VIRGIL C. SUMMER NUCLEAR STATION
DOCKET NO. 50/395
SOUTH CAROLINA ELECTRIC & GAS COMPANY
NOVEMBER, 1981

APPLICANT EVALUATION OF LUCO REPORT ON
VIRGIL C. SUMMER NUCLEAR STATION
SEISMICITY STUDIES

FIGURE 1 V.C. SUMMER, REG. GUIDE 1.60, and RIS SPECTRA, 5% DAMPING

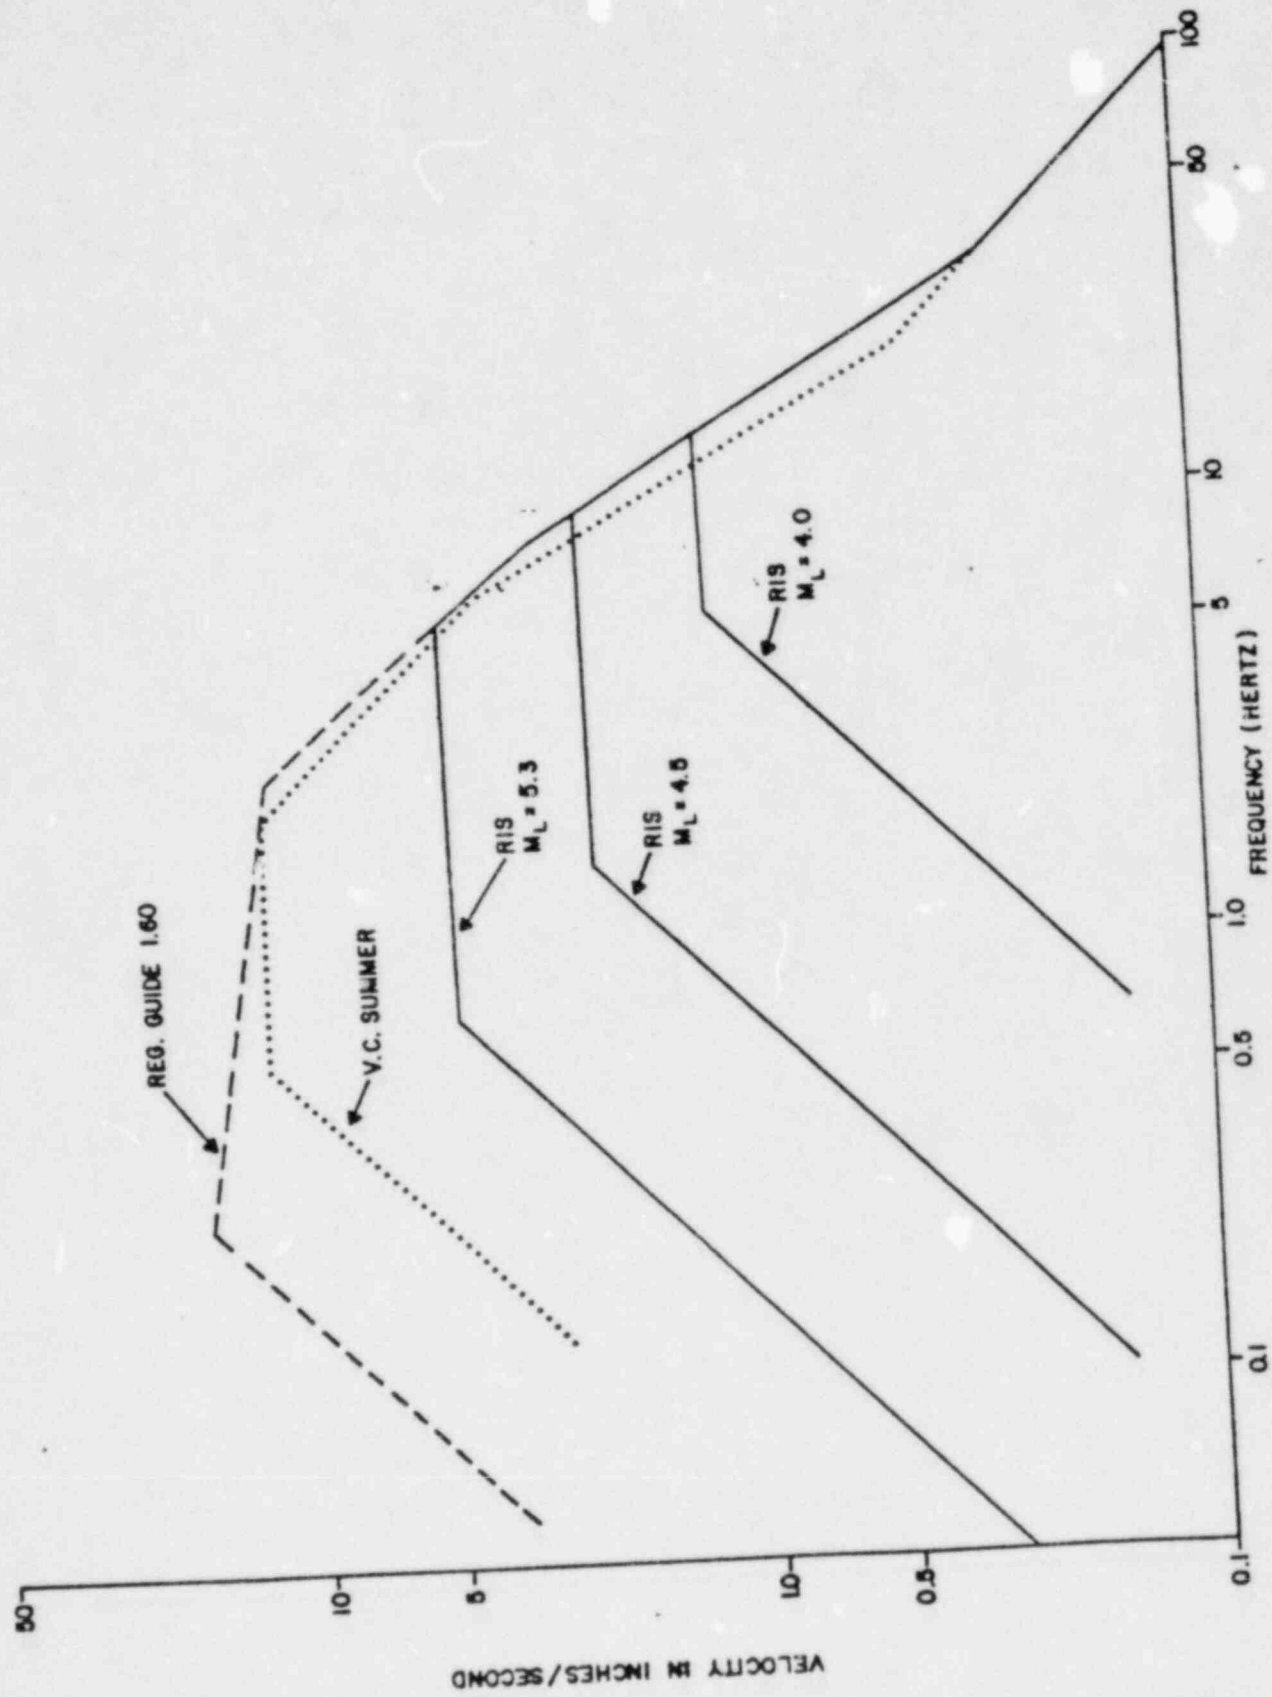
Luco states that it is not appropriate to compare the 5% and 7% SSE spectra with the 2% $M_L=4.5$ spectrum to study the effects on equipment at the lower levels of the plant. This statement (which points to the lack of effect of structural damping for foundation equipment) would be true if a fixed base model were used in the analysis. Since foundation compliance was taken into account in the soil structure interaction analysis and the base mat response was amplified 10% relative to the input motion, it is appropriate to compare the 5% and 7% SSE spectra with the 2% $M_L=4.5$ spectrum for the effects on equipment at the lower levels of the plant.

The conclusions reached by Luco regarding the level of conservatism of response spectra are incorrect. The velocity amplification factor used by Luco (a value of 1.9) is in fact a mean-plus-one standard-deviation ($\text{mean} + \sigma$) amplification factor, not a mean factor. This is apparent from comparisons with Regulatory Guide 1.60 spectral amplification factors and with the ($\text{mean} + \sigma$) amplification factor developed by the Applicant for the velocity range (see Table 3). Thus Luco's pseudo-velocity spectral amplitude for 5% damping of 0.29 ft./sec. is a ($\text{mean} + \sigma$) amplitude, not a mean amplitude.

The shapes for these spectra were taken from the publication of Johnson and Traubenik (1978). These spectral shapes represent ground motions based on records obtained on rock sites for earthquakes with magnitudes (M_L) between 4.7 and 6.5, with source-to-site distances of less than 20 kilometers. The derived spectra for 5 percent damping for $M_L = 4.0, 4.5, \text{ and } 5.3$ events scaled to 0.15 g peak acceleration are

labeled "RIS" in Figure 1. These are mean + σ spectra, based on the amplification factors reported by Johnson and Traubenik (1978). Use of the mean + σ spectrum is consistent with the procedure defined as acceptable for standard design response spectra in Reg. Guide 1.60.

Also shown in Figure 1 are the Reg. Guide 1.60 spectrum for 5 percent damping, and the Virgil C. Summer Nuclear Station SSE spectrum for 5 percent damping, both scaled to 0.15 g acceleration (the SSE acceleration at the facility). It is apparent that the derived RIS spectra generally match both the Virgil C. Summer spectrum and the RG 1.60 spectrum at the highest frequencies, but deviate at intermediate and low frequencies, the extent depending on both the earthquake magnitude and the frequency of interest. The reason for this deviation is that broad-banded design spectra typically represent ground motions for earthquakes of magnitude around 6-1/2 (they are derived from recorded ground motions during seismic events with an average magnitude of 6-1/2). The RIS spectra, on the other hand, logically reflect the lack of intermediate and low frequency energy which will be generated during magnitude 4.0 to 5.3 earthquakes with small source to site distances.

Two steps are required to generate site-specific spectra of the type shown in Figure 1, and in comparing these spectra to other results available it is convenient to break the comparison into these two steps. The first step is the estimation of a peak velocity and a peak displacement which are consistent with the peak acceleration of the earthquake of interest. In the present application, the peak velocity-to-acceleration ratio is most critical because it determines the upper corner frequency of the spectrum. The peak displacement is not important in the present application because the Virgil C. Summer SSE spectrum greatly exceeds the RIS spectra in the displacement-controlled region (at lower frequencies).

The RIS spectral amplifications shown in Table 3 indicate that the representation of reservoir-induced earthquake ground motions is appropriate. These amplifications generally agree with those of RG 1.60, particularly for the higher dampings (5 percent to 10 percent) characterizing structures critical for safe shutdown of the facility, and particularly for the higher frequencies in each range. The Johnson and Traubenik (1978) results on which the RIS amplifications are based were derived for events recorded specifically on rock sites at small source-to-site distances, whereas the RG 1.60 results were obtained from a variety of sites and source-to-site distances. Thus, it would be logical if the uncertainty in spectral amplification would be less for the RIS spectra than for the RG 1.60 spectra; this would result in lower mean + σ spectral amplification for the RIS spectra. The results for 0.5 percent damping undoubtedly reflect this difference in the data sets. This difference in no way detracts from the RIS spectra results: the site and distance conditions of the records on which these results are based more closely reflect the conditions expected during reservoir-induced earthquakes at Monticello Reservoir than do generic broad-banded spectra.

In summary, the spectra developed to represent reservoir-induced earthquake ground motions are based on records obtained at close distances on rock sites. These spectra are consistent with published work of other investigators; they represent mean + σ spectra and have been developed to meet the requirements of RG 1.60.
